**Brick & Bolt**  
 ClayWorks CBD, Shoba Alexander Plaza, Ashok Nagar, Bengaluru, Karnataka 560025

Project  
 Residence for Mr. VINAY

CRN 152732  
 Drg. No. A101  
 Date 04-11-2022  
 Drawing Title GROUND FLOOR PLAN- R3  
 Scale 1:80

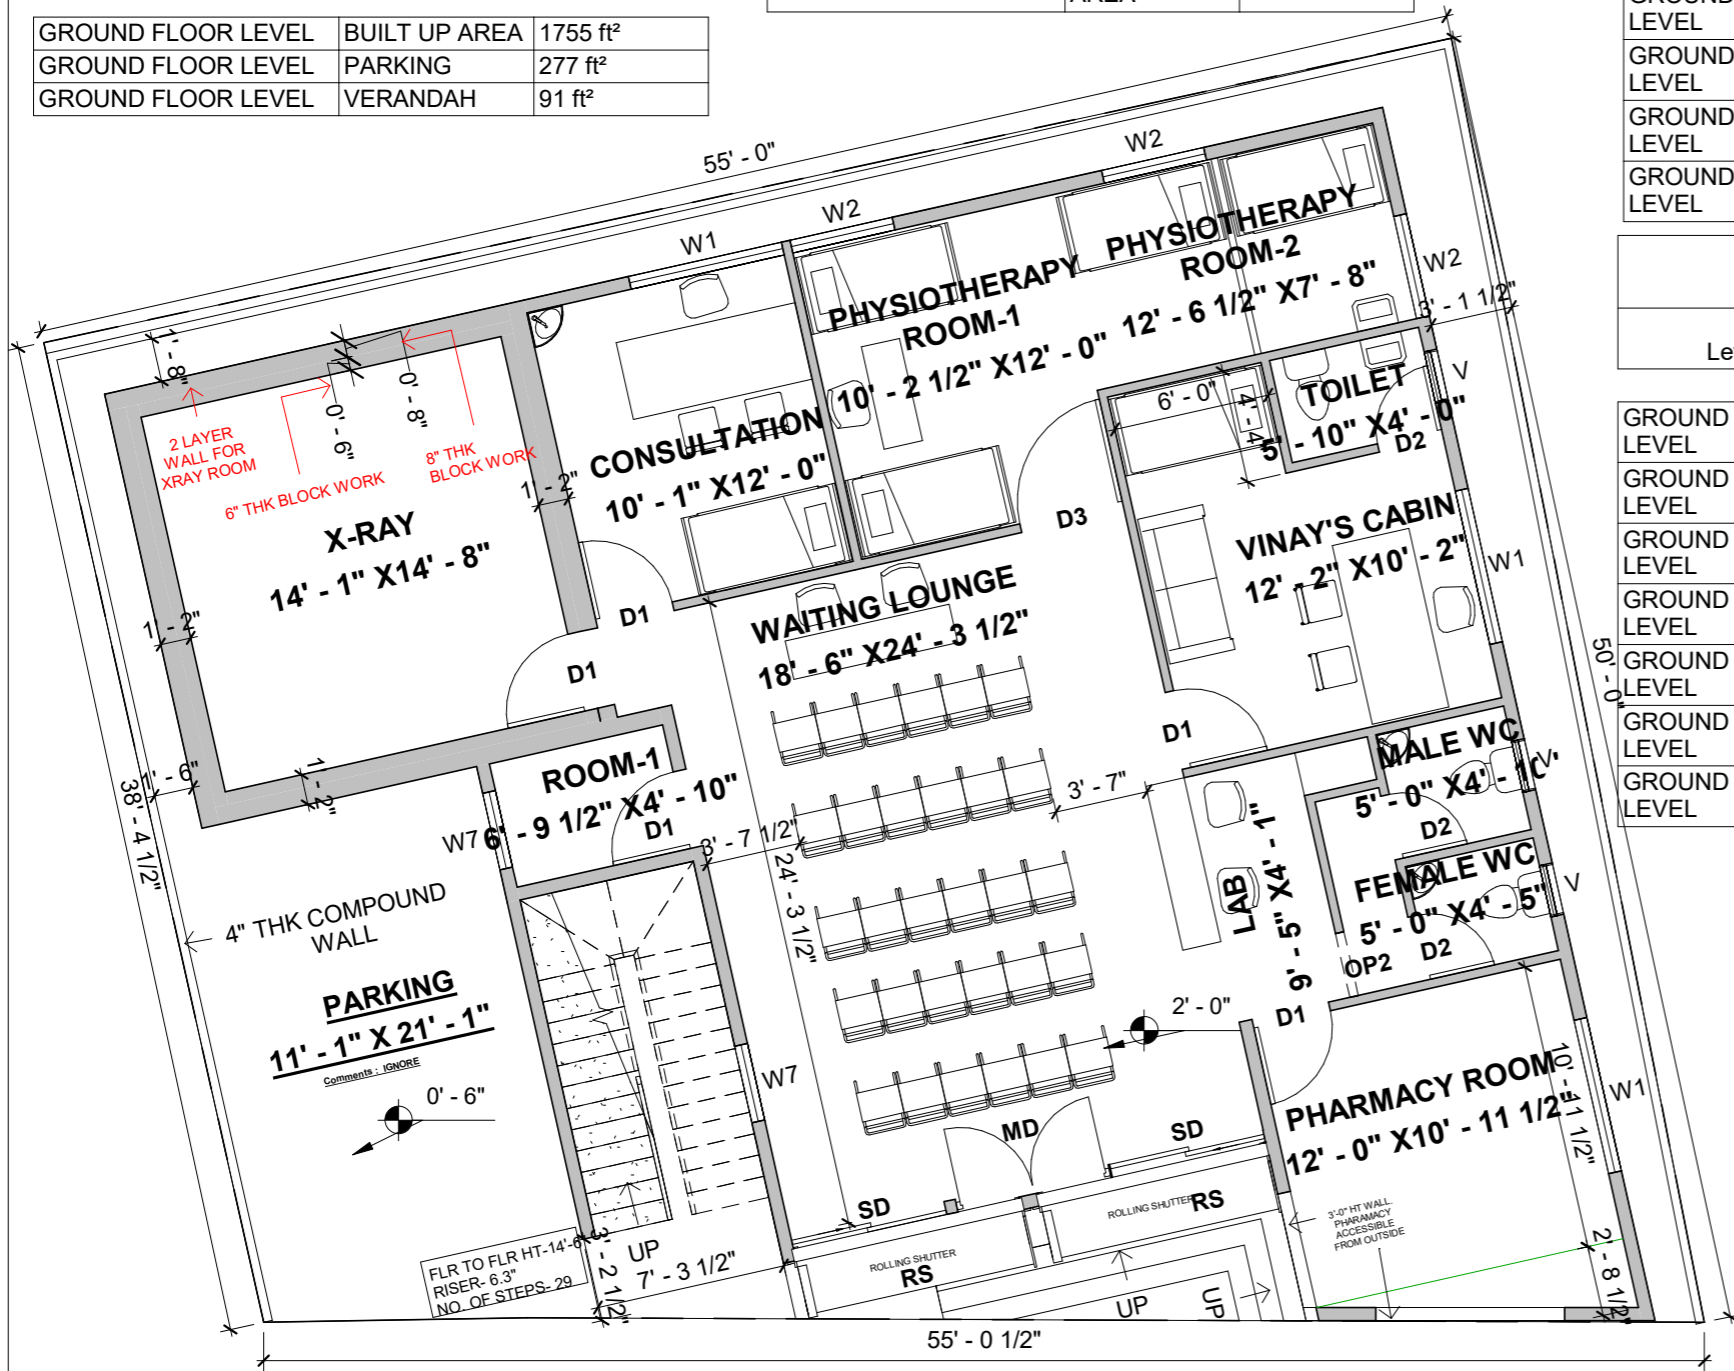
- GF  
 1. XRAY - ROOM DIMENSIONS ALTERED & WALL THICKNESS 8"+6"= 14" BLOCK WORK  
 2. WASH BASIN ADDED IN PHYSIOTHERAPY ROOM
- FF  
 1. BALCONY ADDED TO GUESTROOM & HOMEOFFICE  
 2. TOILET ADDED TO ROOM-3
- SF  
 1. BALCONY ADDED TO HOMETEATRE & KIDS ROOM

Drawing Title  
FIRST FLOOR PLAN-R3

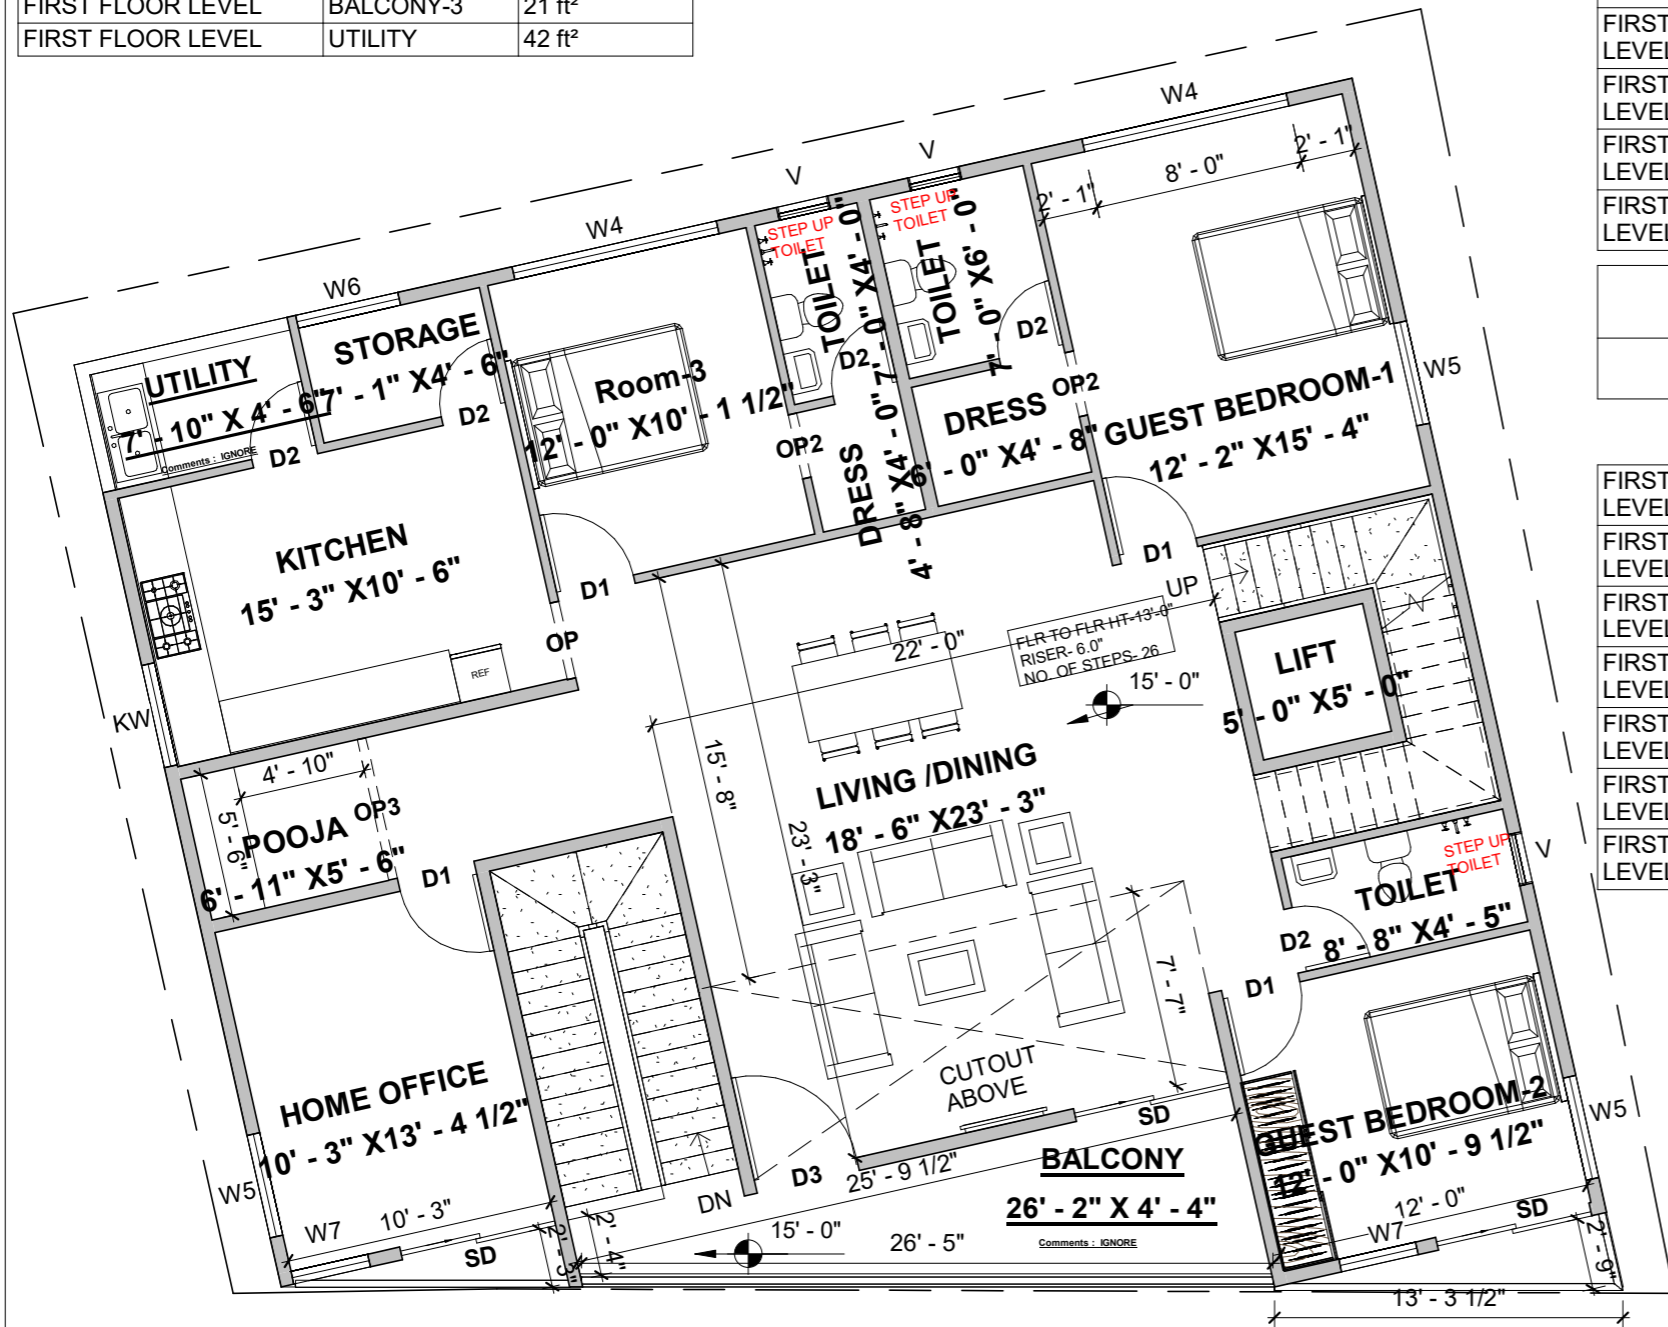
FF  
1. BALCONY ADDED TO GUESTROOM & HOMEOFFICE  
2. TOILET ADDED TO ROOM-3

Drawing Title SECOND FLOOR PLAN- R3

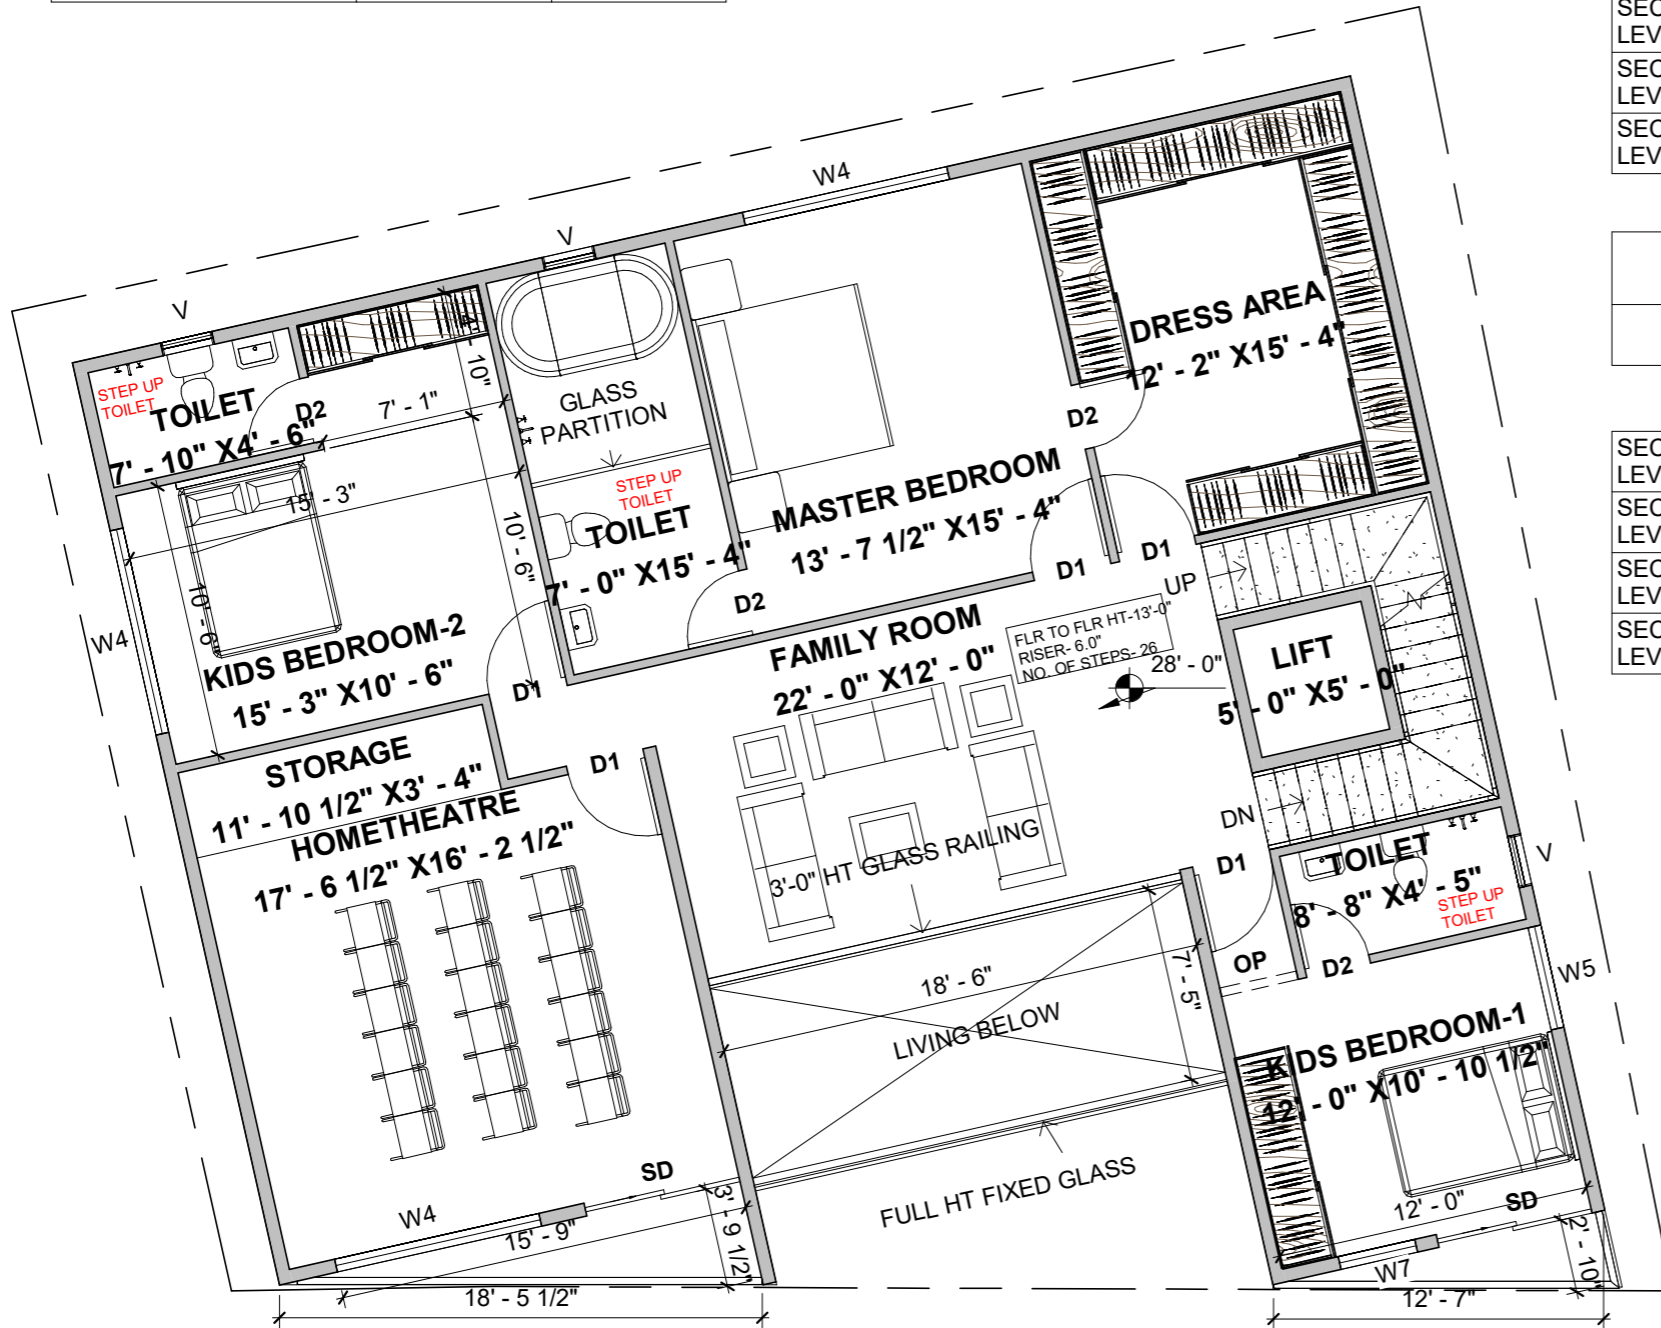
- GF  
 1. XRAY - ROOM DIMENSIONS ALTERED & WALL THICKNESS 8"x6" = 14" BLOCK WORK  
 2. WASH BASIN ADDED IN PHYSIOTHERAPY ROOM
- FF  
 1. BALCONY ADDED TO GUESTROOM & HOME OFFICE  
 2. TOILET ADDED TO ROOM-3
- SF  
 1. BALCONY ADDED TO HOMETHEATRE & KIDS ROOM
